**Re: 3071 Riverside Drive – Canoe Bay Development
 Transportation Impact Study – Addendum #1**

This Addendum to the original Community Transportation Study/Transportation Impact Study (CTS/TIS) has been prepared to identify the transportation-related changes to the Site Plan and address any impacts these changes will have on the overall results of the original study. The revised Site Plan is attached and includes the following transportation-related changes:

Figure 1: Total Projected 2024 Traffic Volumes

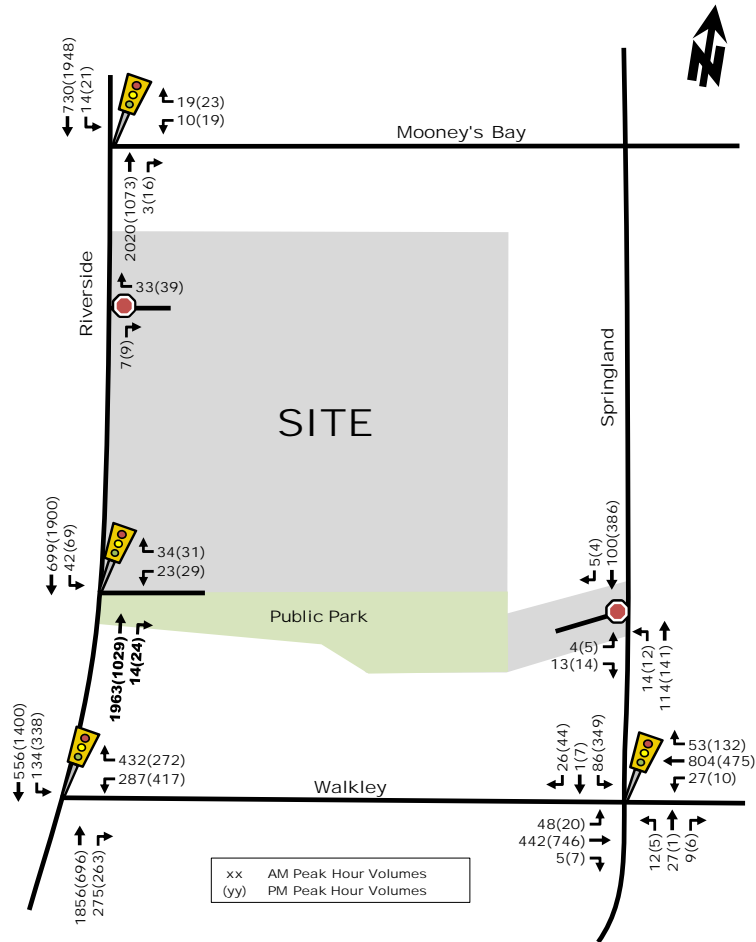
With regard to the relocation of the daycare and the increase in vehicle parking supply along Springland Drive, the resulting vehicle trip distribution will be similar to the original TIS/CTS. As shown, approximately 20 two-way veh/h are projected to travel along Springland Drive to/from the proposed parking lot, which equates to less than 1 vehicle every three minutes along this local road.

The removal of the right-in/right-out vehicle access to the underground parking lot will increase vehicle traffic at the proposed signalized access and the right-in/right-out driveway connection to Riverside Drive at the north end of the site. In addition, it will likely reduce the number of U-turns at the proposed signalized access (Riverside/Site). The revised trip distribution is illustrated in Figure 1. Based on this redistribution of vehicle traffic, the resulting signalized access to the site is projected to operate acceptably, as shown in Table 1.

OVERALL SITE PLAN

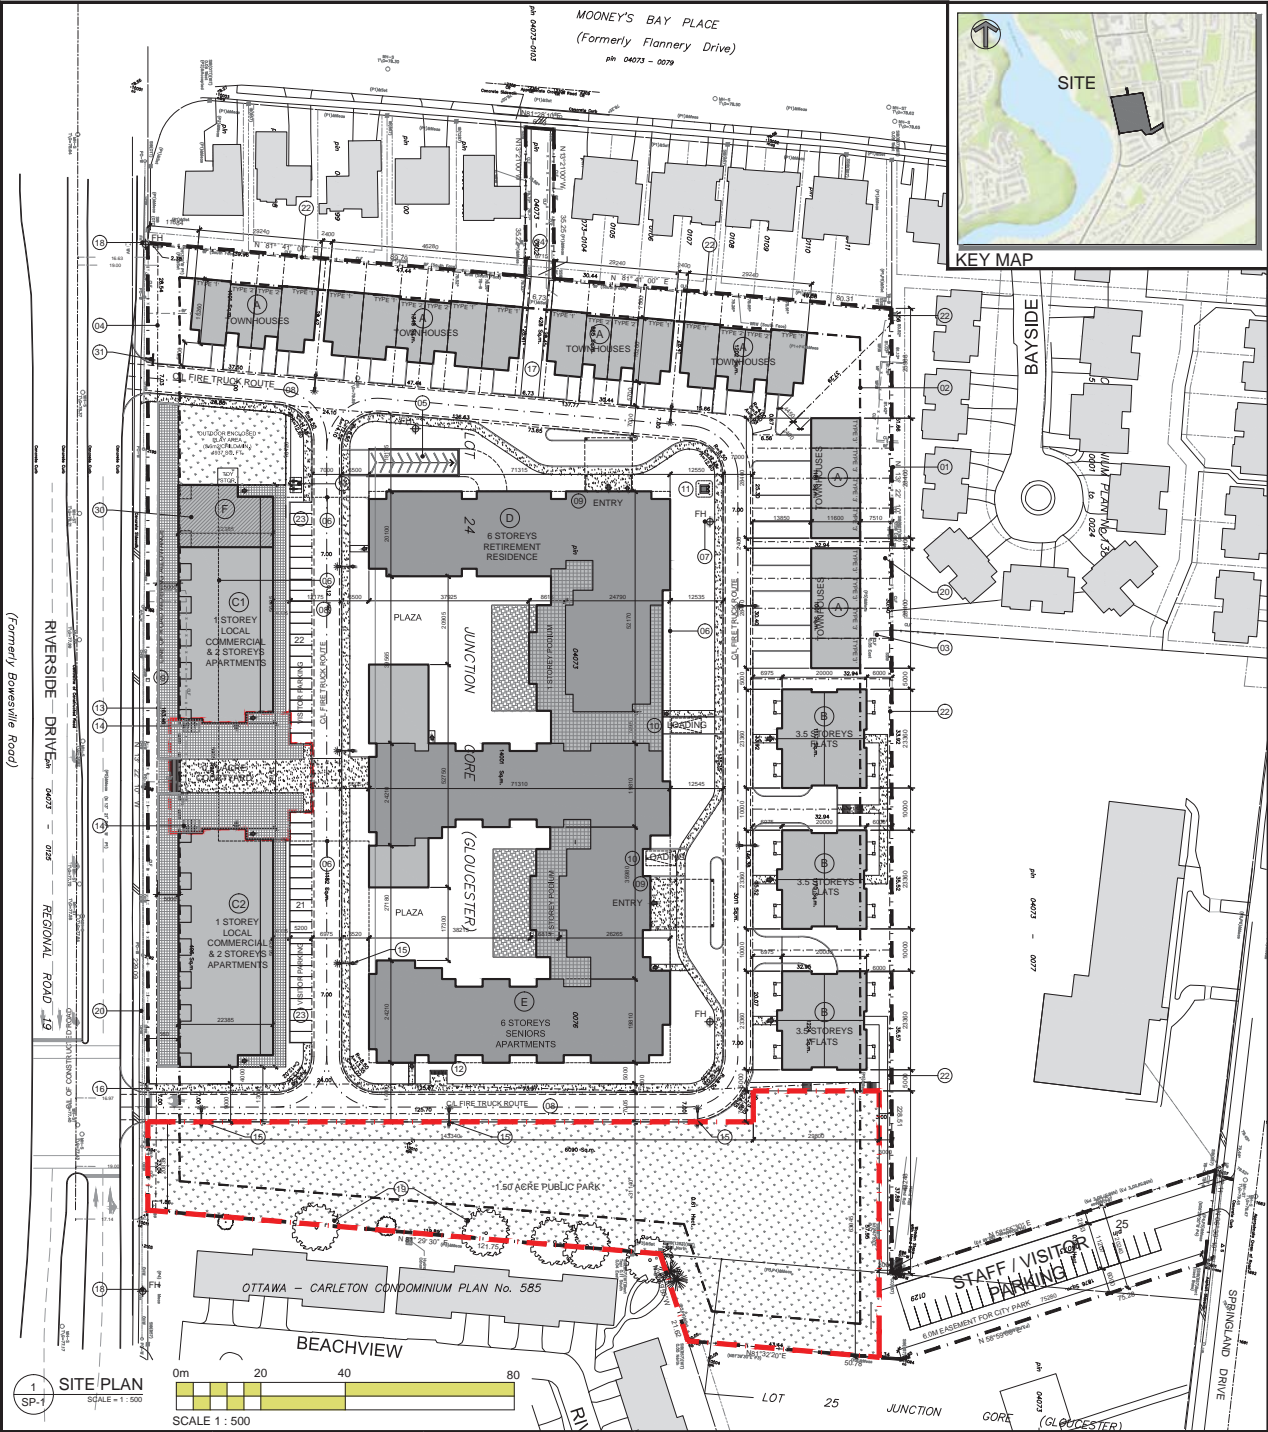
- Removal of the right-in/right-out driveway connection to Riverside Drive which provides direct access to underground parking garage;
- Slight decrease in residential units from 627 to 617 units;
- Slight increase in parking from 434 to 460 spaces;
- Relocation of the day-care facility from Springland Drive to ground floor of the northwest building; and
- Increase parking lot size on Springland Drive from 11 spaces to 25 spaces (staff parking).

With regard to the change in residential units, this will have a negligible impact on the trip generation analysis from the original report. The revised vehicle parking supply for the entire site meets the City’s By-Law requirements. It is noteworthy, however, that for Building Type ‘B’ (apartments) and ‘C’ (mixed-use), the parking is slightly undersupplied and for Building Type ‘D’ and ‘E’ (retirement home) the proposed provided parking is over the minimum requirement by approximately 90 spaces. This is outlined on the revised Site Plan.
